NP-11-0021
June 2, 2011

Subject: Exelon Nuclear Texas Holdings, LLC
Victoria County Station Early Site Permit Application
Response to Request for Additional Information Letter No. 08
NRC Docket No. 52-042

RAI 02.04.12-5:**Question:**

RAI 02.04.12-6:**Question:**

Figure 2.4.12-26a Plan View Showing Locations of Orthogonal Cross-Sections

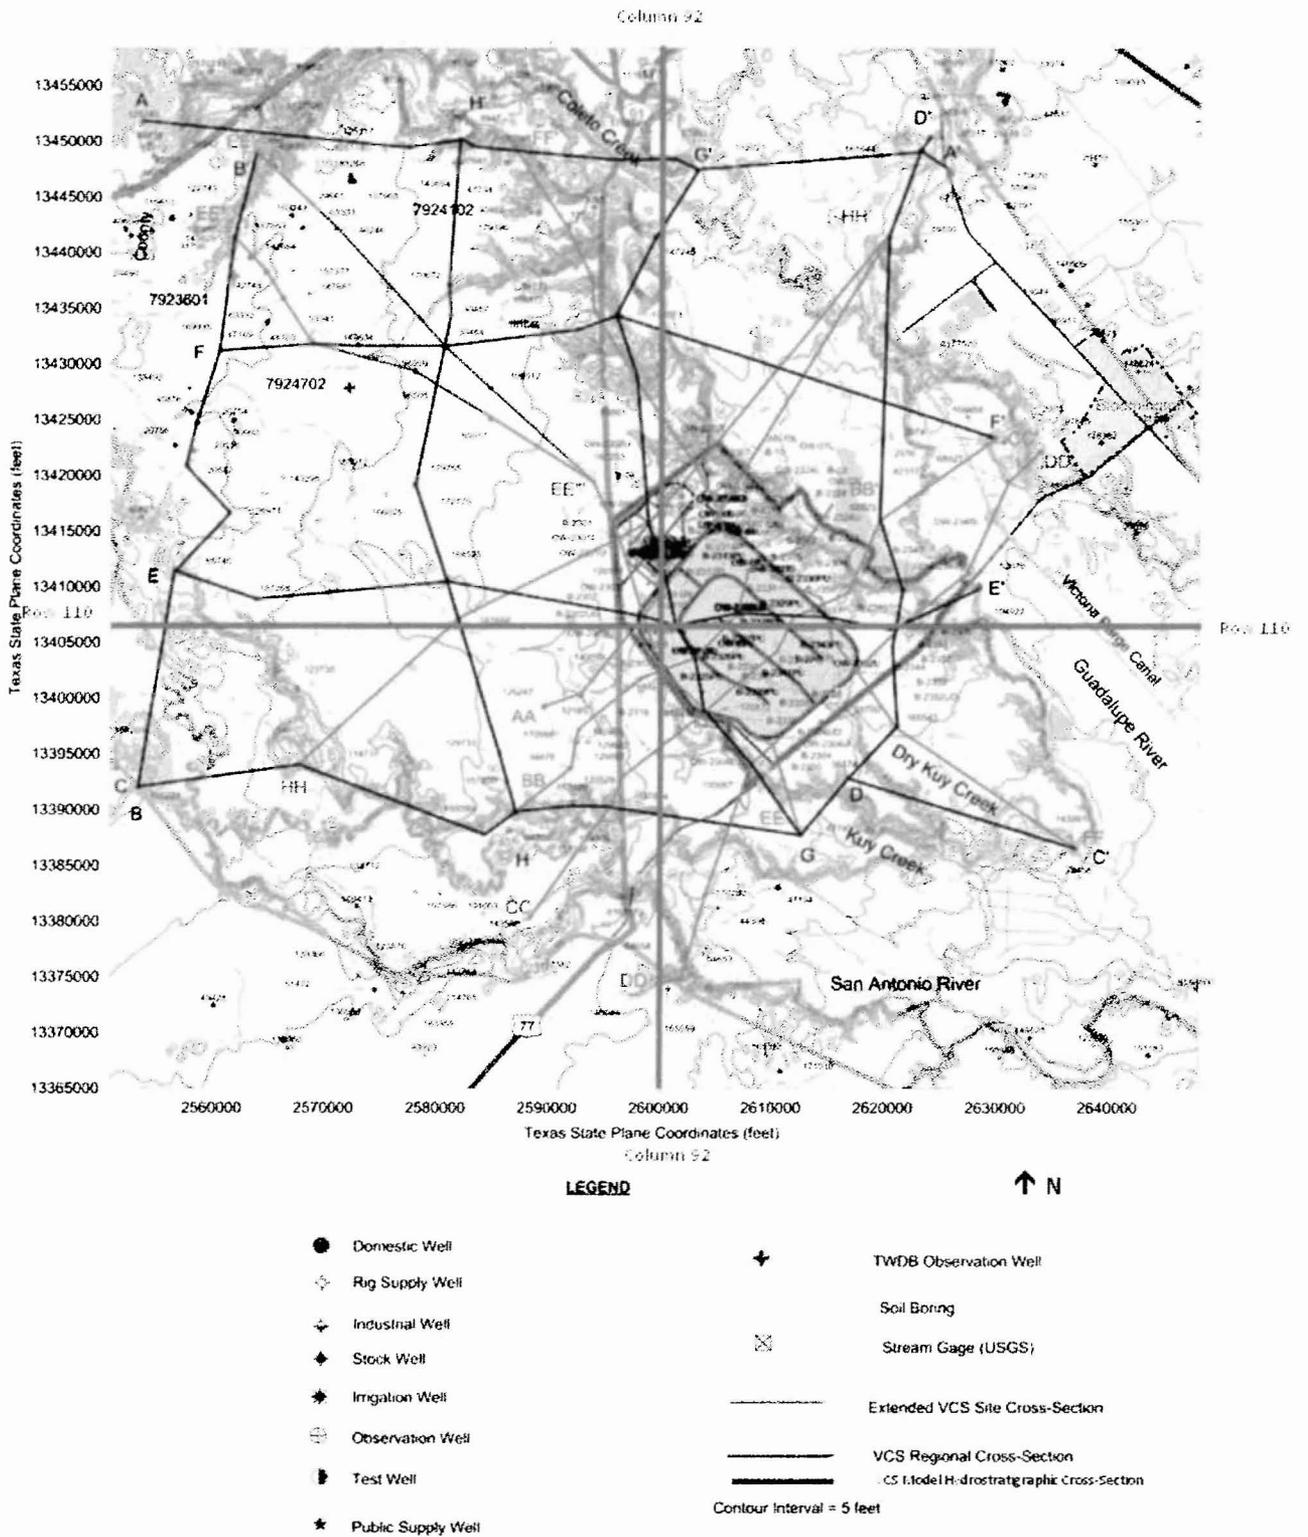
In accordance with the requirements of 10 CFR 100.20(c) "Factors to be considered when evaluating sites" relating to hydrology and, 10 CFR 52.79(a) "Contents of applications; technical information in final safety analysis report" relating to hydrologic characteristics of the proposed site, and as recommended by Standard Review Plan 2.4.12 "Groundwater" acceptance criteria, the NRC Staff requests that the Applicant provide: (1) A detailed description of how various site specific hydro-lithologic units were defined, particularly the distinction between the upper shallow and lower shallow aquifer units subdividing the Chicot aquifer; and (2) A discussion of the importance or influence of holes in confining units beneath the footprint of the site and cooling basin on vertical groundwater gradients and movement during post-construction.

In addition, driller's logs obtained from the Texas Water Development Board of 72 water wells in the vicinity of the VCS site were used to assist in interpretation of the stratigraphy near the site. The elevations of the bottom of each soil layer noted in these well logs were correlated with those from onsite soil borings and cone penetrometer soundings to extend several cross-sections offsite and construct additional regional cross-sections that extend across the domain of the VCS numerical model. The locations of these cross-sections are shown on Figure 2.4.12-26a.

Figure 2.4.12-26a Plan View Showing Locations of Orthogonal Cross Sections

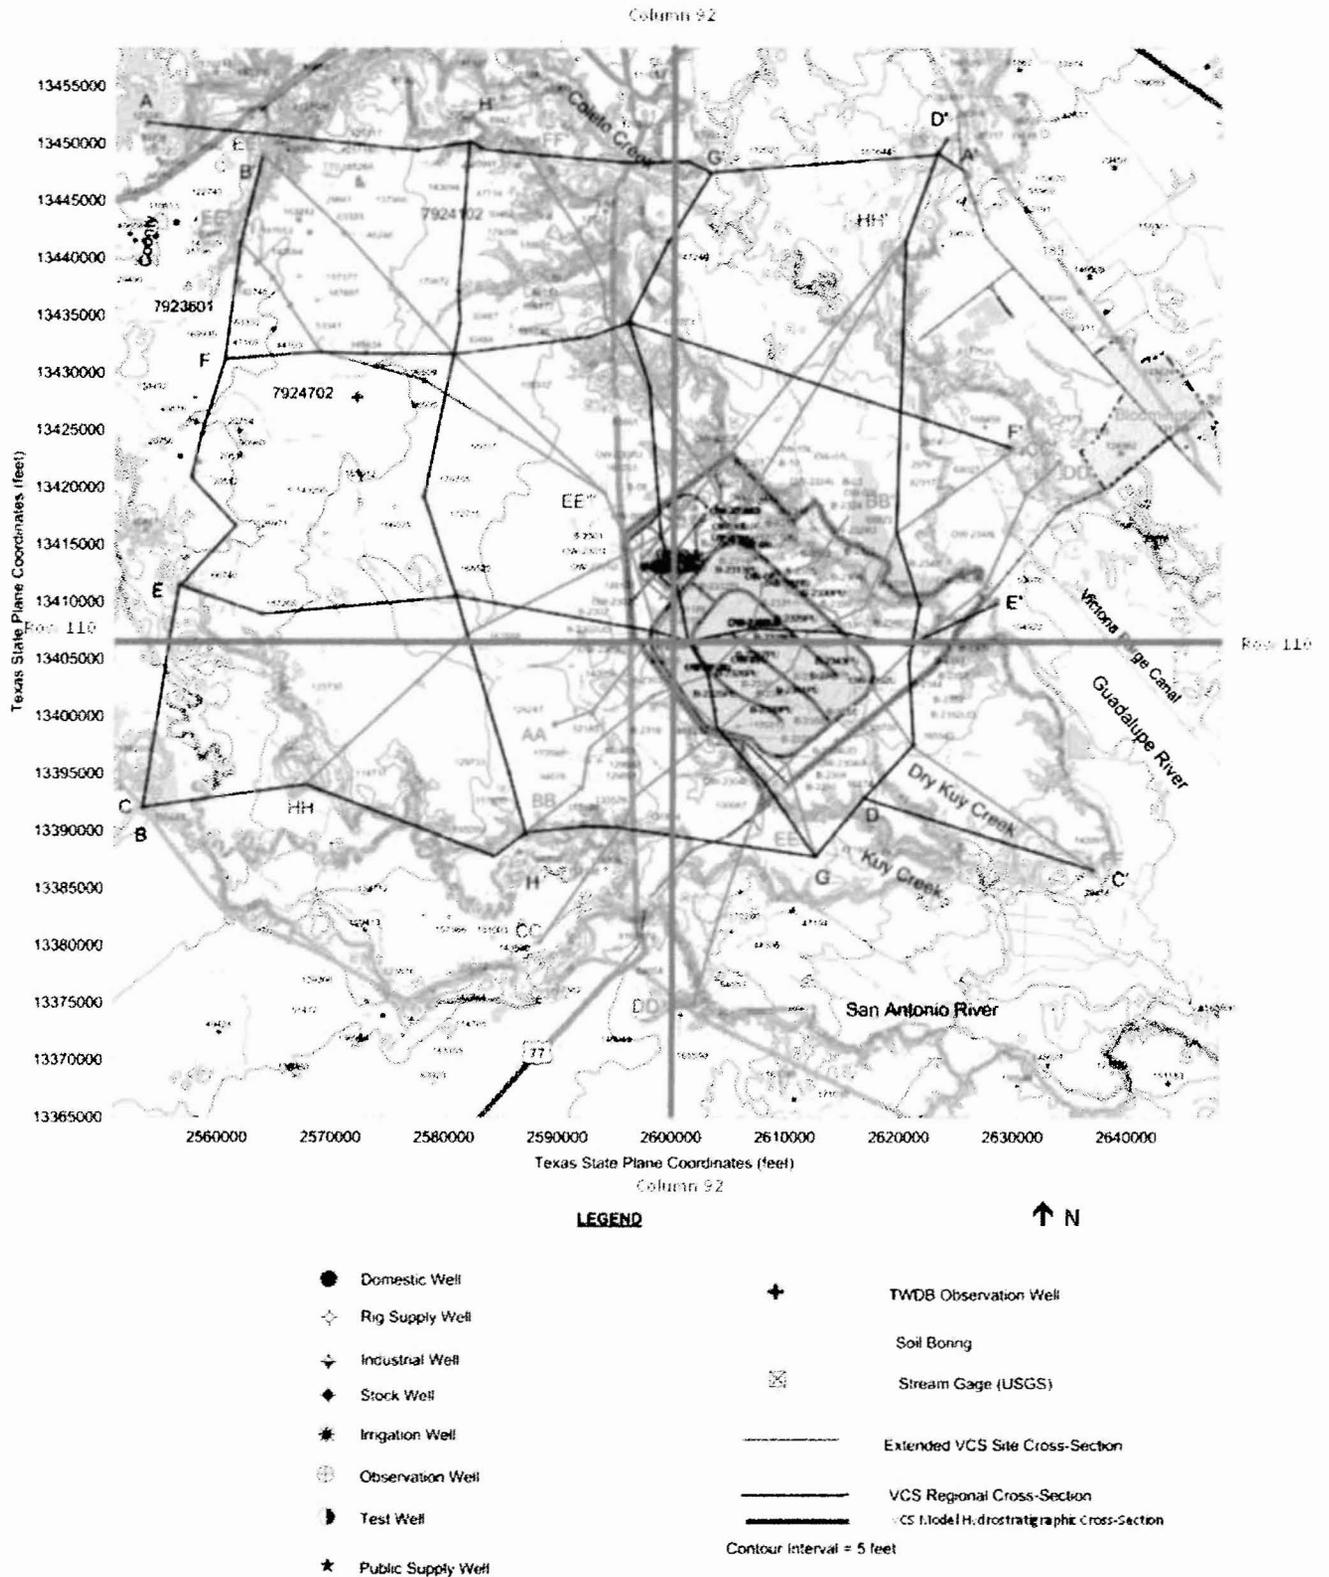
In accordance with the requirements of 10 CFR 100.20(c) "Factors to be considered when evaluating sites" relating to hydrology and, 10 CFR 52.79(a) "Contents of applications; technical information in final safety analysis report" relating to hydrologic characteristics of the proposed site, and as recommended by Standard Review Plans 2.4.12 "Groundwater" acceptance criteria, the NRC Staff requests that the Applicant provide: (1) Two orthogonal cross-sections across the site with the hydro-lithologic units labeled consistent with site nomenclature and include the vertical direction of ground water flow and the potentiometric surfaces for the hydrologic layers; and (2) Two orthogonal cross sections (replacing or adding to FSAR, Rev0, Figure 2.4.12-26), of the model grid that approximate the location of the two hydro-stratigraphic cross-sections in (1) above.

The locations of the cross sections are shown in Figure 2.4.12-26a.
